TECHNICAL BULLETIN	
	June 1999 TB 1703
Mfg:	GM
Model:	C-SERIES
Liter:	6.0L
V I N:	U
Year:	99-06

Revised Oil Gallery Plug Location On
1997-99 GM 4.8, 5.3, 5.7 & 6.0L Engines

Bulletin Diagram: Untitled Graphic #2408 for TB 01703

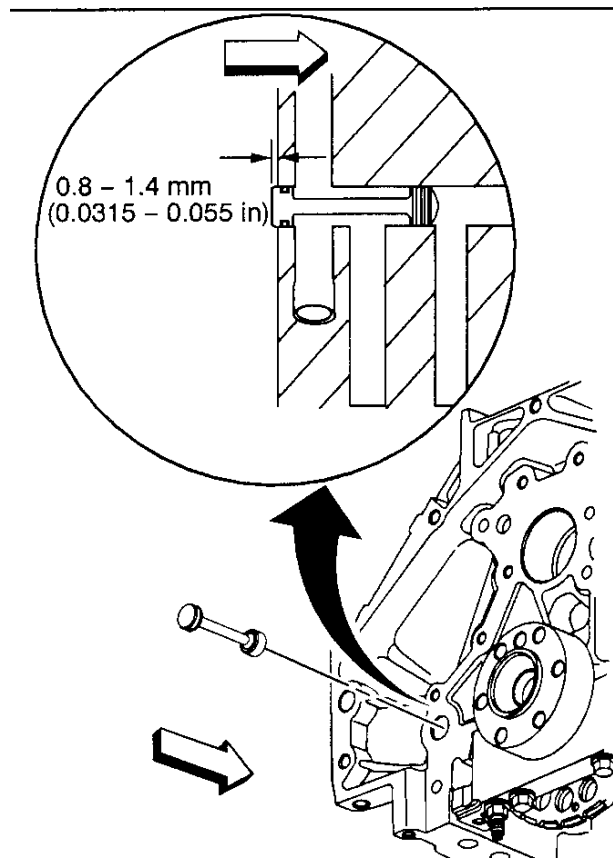
The AERA Technical Committee offers the following information regarding a revised oil gallery plug location on 1997-99 GM 4.8, 5.3, 5.7 & 6.0L engines. This information applies only to the new GEN III engines that were introduced in 1997. An engine block rear oil gallery plug location was misstated in original service manual publications. If this plug is installed as indicated in those publications, engine oil flow may be restricted as a portion of the plug may extend into main oil galley.

Original service manual information indicated the plug should be recessed below the rear block face .031-.055" (.08-1.4mm). The correct location should show the plug protruding beyond the rear block face .031-.055" (.08-1.4mm) as shown below in Figure 1. The front portion of this plug incorporates a small O-ring, which may be re-used if it is not damaged.
